Reference: 24.037r01v03

**RE: 22 Central Avenue, Manly  
Request For Information Response Letter (RFI) (DA2023/1358)**

TRAFFIX has received comments from Council relating to the subject development. TRAFFIX has reviewed the traffic related items and has provided a response to each item, which has been reproduced below for reference:

SHEET NAME:	<b>BASEMENT PLAN</b>
OWNER AND PROJECT LOCATION:	The Owners Corporation SP7114 22 Ground Floor. 22, Central Avenue, Manly NSW

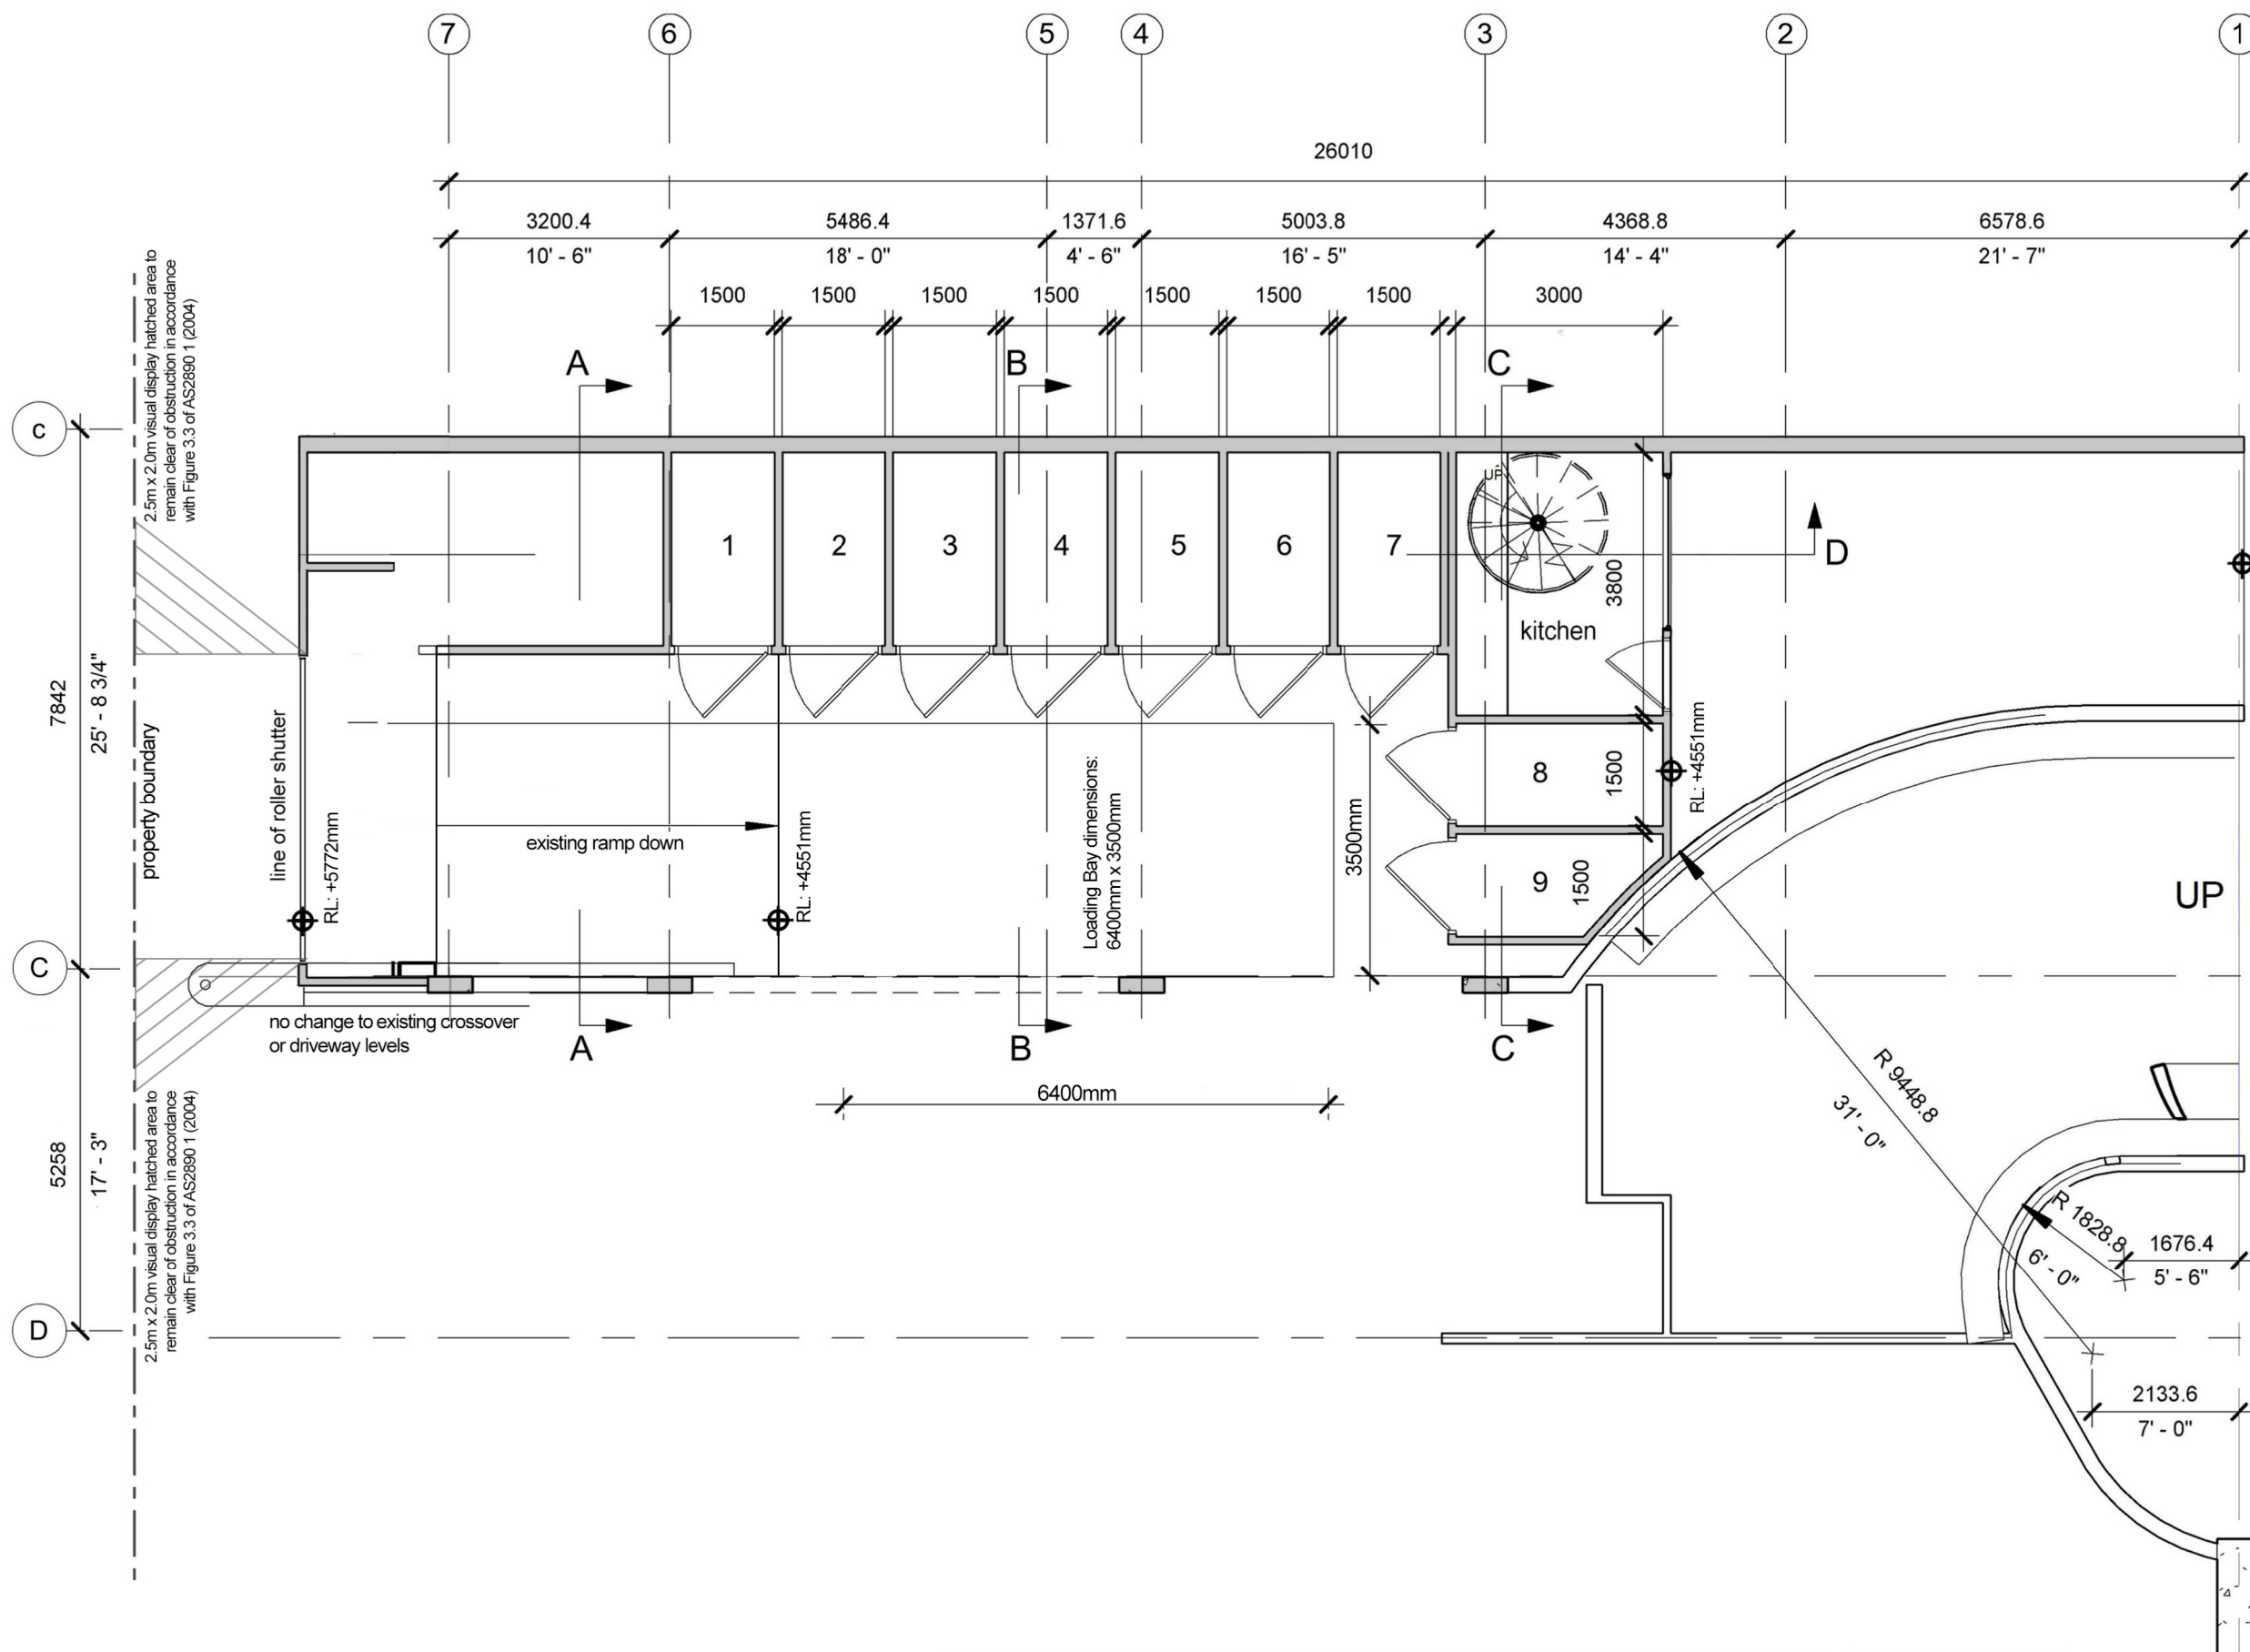
- The Ground level loading bay at the Short Street entrance is measured to be approximately 10.5 meters long, which can accommodate trucks up to and including 8.8m long Medium Rigid Vehicles (MRVs). The loading dock on the Basement Level is measured to be about 7.5m long and can fit vehicles up to and including a 6.4m long Small Rigid Vehicles (SRVs). The loading bay widths within the site however have not been dimensioned on the architectural plans. Dimensioned plans are to be submitted for the loading areas to confirm that loading bays are appropriately sized".*

For clarity, it is noted that the subject site contains one (1) loading dock located within the basement loading bay with access via Short Street. Reference should be made to the Architectural Plans provided in **Attachment 1** showing the loading bay dimensions notated on the plans.

A pedestrian sight line triangle measuring 2.0 metres by 2.5 metres has been provided at the property boundary in accordance with AS2890.1:2004. Reference should be made to the architectural plans presented in **Attachment 1** showing the plotted sight triangle at the access for pedestrian visibility for exiting trucks.

**Drawing Title**  
 Swept Path Analysis  
 6.4m Small Rigid Vehicle (MRV)  
 Reverse Entry Manoeuvre into Loading Dock via Short Street

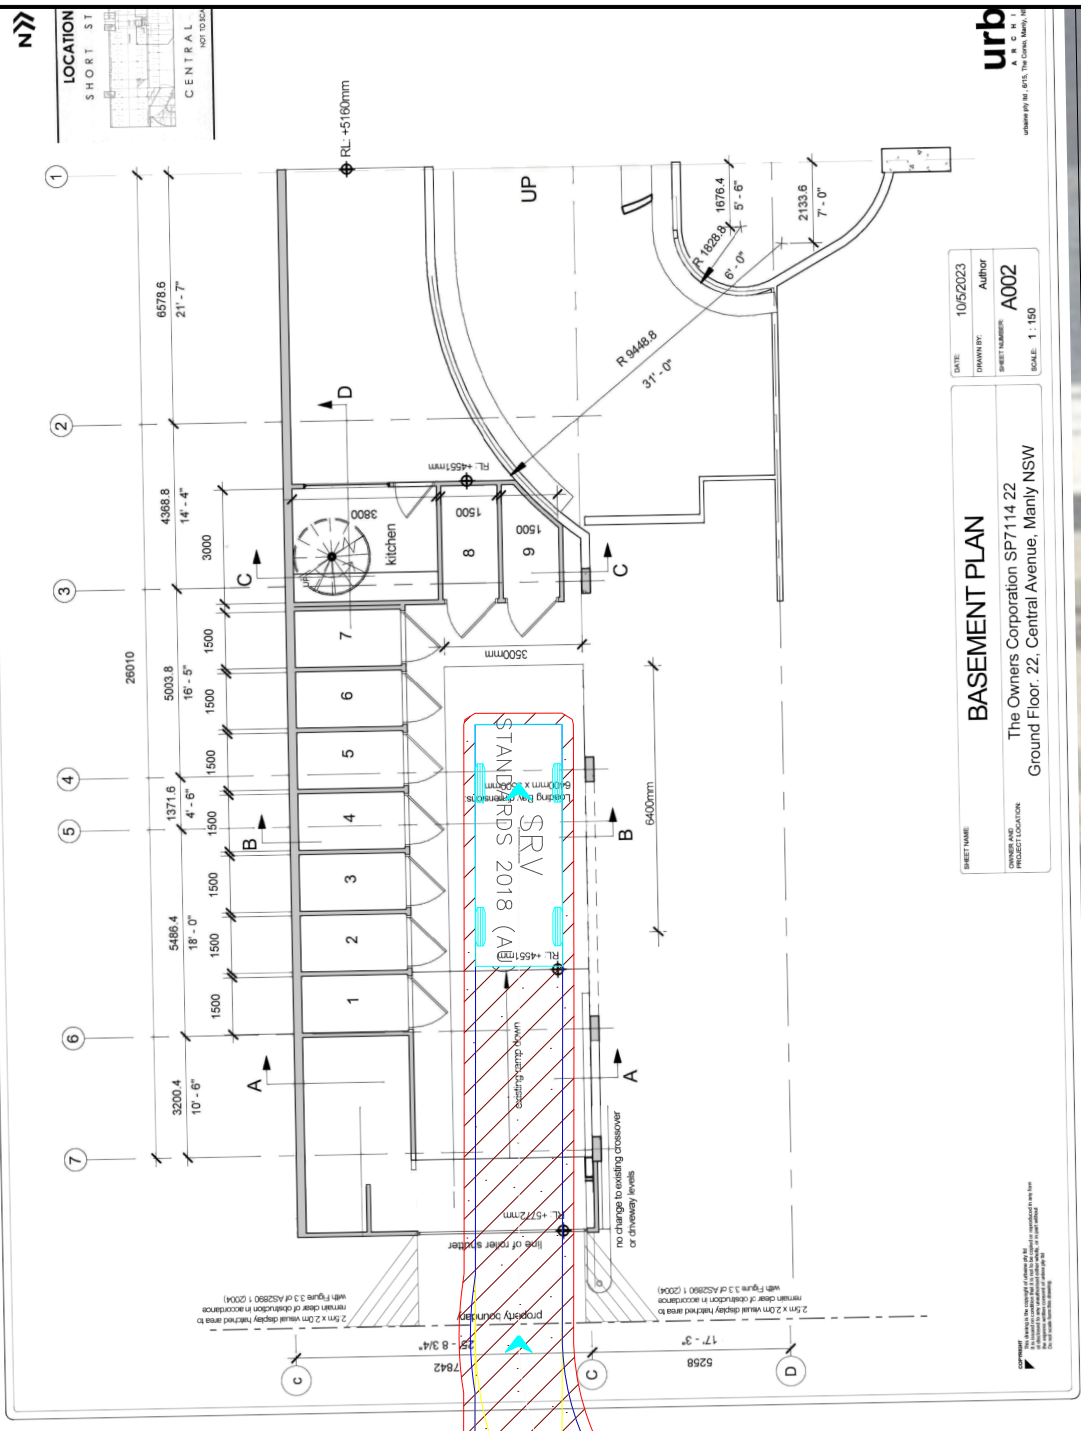
- No swept path analysis has been provided to show the loading bays can support ingress and egress from Short Street. Swept path analysis should be undertaken to demonstrate that the entry and exit movement is possible from/to the loading bays. Council requires some information on*

Reference should be made to the Swept path Analysis presented in **Attachment 2** showing the satisfactory operation of the loading dock with reverse entry and forward egress manoeuvres via Short Street using a 6.4m Small Rigid Vehicle (SRV), the largest vehicle requiring access to the loading bay.
